**RE: Chick-Fil-A @ Coors Pavilion
Coors Pavilion, Lot 6
Grading and Drainage Plan
Engineer's Stamp Date: 9/4/18
Drainage File: G11D069C**

Based on the information provided in your submittal received 9/7/18, the Grading and Drainage Plan cannot be approved until the following are addressed:

**Re: Chick-Fil-A@ Coors Pavilion; Coors Pavilion, Lot 6; Conceptual Grading and Drainage Plan;
Engineer's Stamp Date: 11/22/17; Drainage File: G 11D069C**

UTILITY PLAN

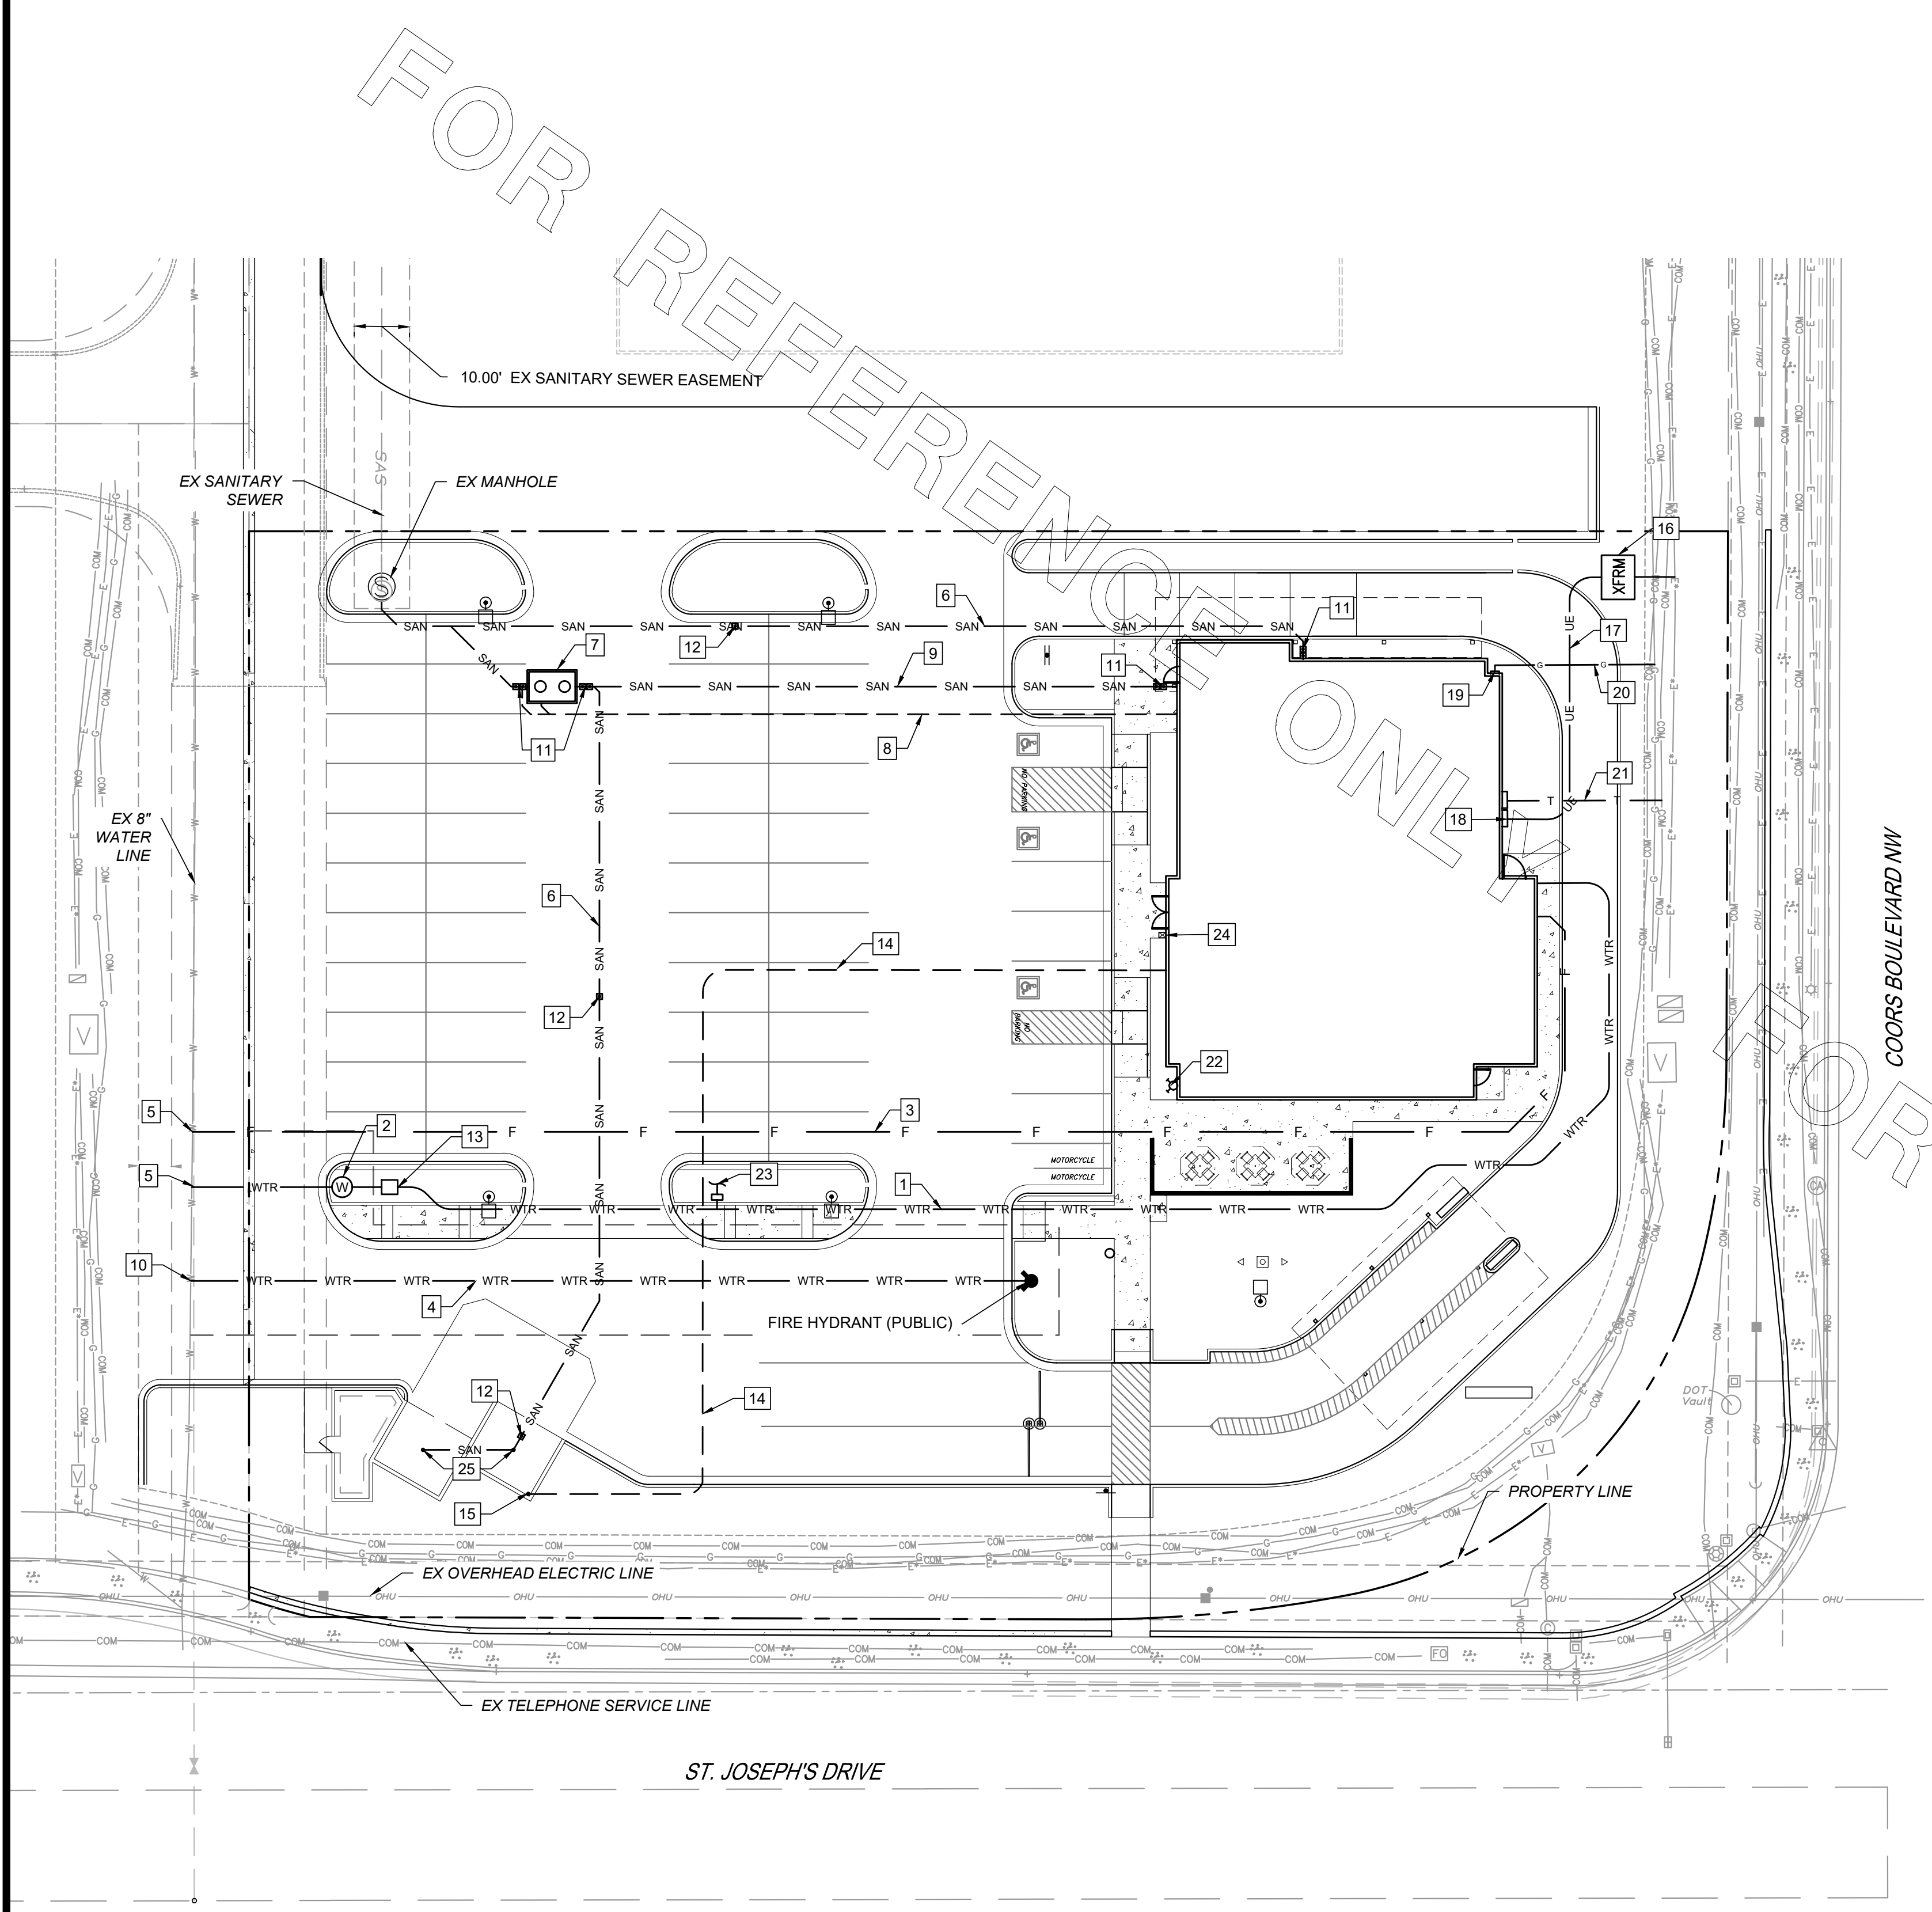
7. For trash enclosures serving food service developments, please include a drain line to a grease trap and then drain into the sanitary sewer. If this information is on the utility plan please provide it, or show on the grading plan.

Response: The Utility Plan has been provided with the latest submittal.

- 19 GAS METER
- 20 GAS SERVICE LINE
- 21 TELEPHONE SERVICE LINE
- 22 FIRE DEPARTMENT CONNECTION
- 23 CONNECT TO IRRIGATION SYSTEM
- 24 KNOX BOX
- 25 TRASH ENCLOSURE AREA DRAIN. CONNECT TO PROPOSED SANITARY SEWER LINE.
